907 CHURCH STREET SUBDIVISION

Engineering Comments: FINAL PLAT COMMENTS (should be addressed prior to submitting the FINAL PLAT for review and/or signature by the City Engineer):

APPLICATION NUMBER 2 DATE September 15, 2022

APPLICANT 907 Church Street Subdivision

DETAIL SITE PLAN

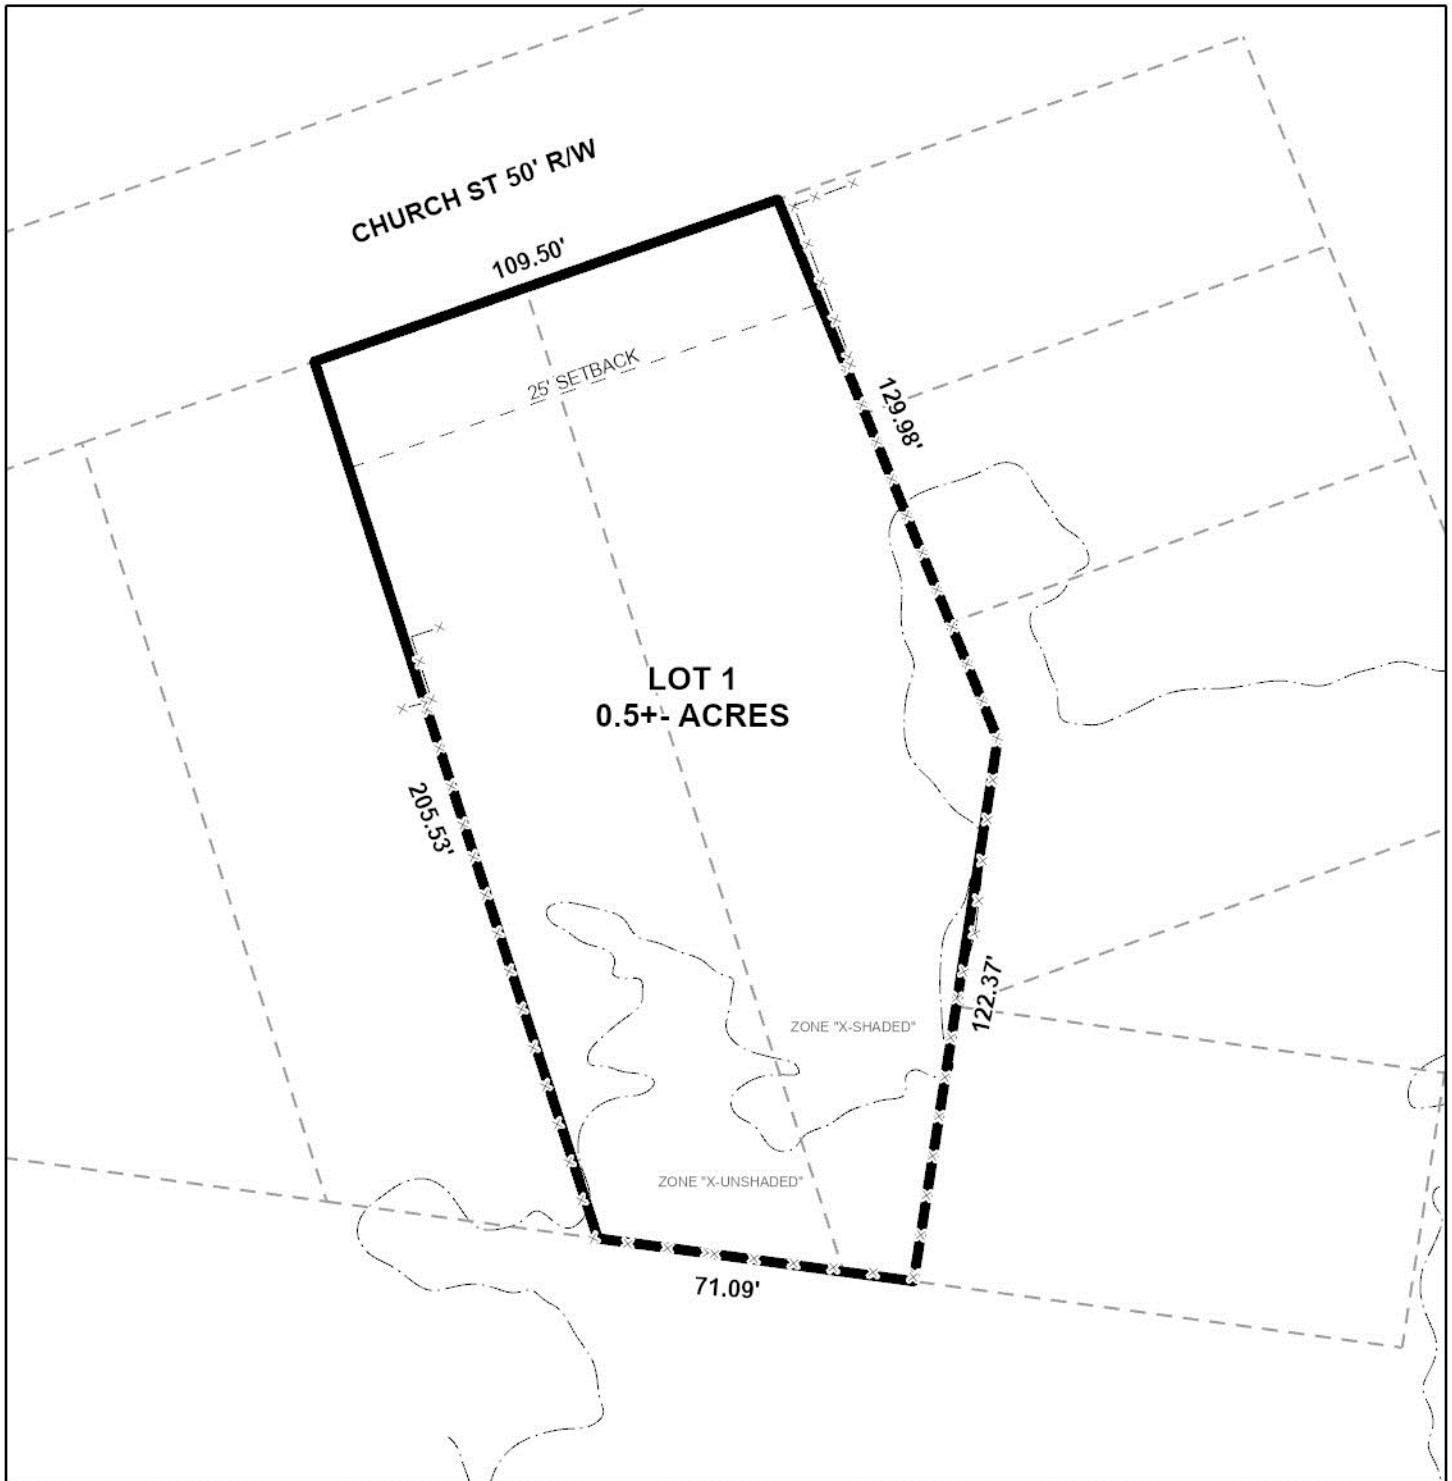
The proposed site has frontage on Church Street, a minor street with curb-and-gutter requiring a 50-foot right-of-way. The preliminary plat illustrates a complaint 50-foot right-of-way at this location; thus, no additional dedication is required. As on the preliminary plat, the right-of-way width of Church Street should be retained on the Final Plat, if approved.

The preliminary plat submitted indicates a proposed 25-foot minimum building setback line along Church Street, as required by Section V.D.9 of the Subdivision Regulations. However, it should be noted that the site is within the Oakleigh Garden Historic District, and relief from the normal building setbacks and site coverage limitations of the Zoning Ordinance is automatically granted by the Historic District Overlay provisions of Section 64-3.G. If approved, it is recommended that Section V.D.9. of the Subdivision Regulations be waived, and that a note be placed on the Final Plat stating that all setbacks shall be determined by the Historic District Overlay requirements of the Zoning Ordinance.

The proposed lot is approximately 23,701± square feet which exceeds the minimum size requirements of the Subdivision Regulations.

As per the Traffic Engineering comments, the driveway number, size, location, and design are to be approved by Traffic Engineering and conform to AASHTO standards. If approved, a note should be required on the Final Plat stating these comments.

- 1) Retention of the right-of-way width of Church Street on the Final Plat;
- 2) Removal of the 25-foot minimum building setback line along Church Street and placement of a note on the Final Plat stating all setbacks shall be determined by the Historic Overlay requirements of the Zoning Ordinance;
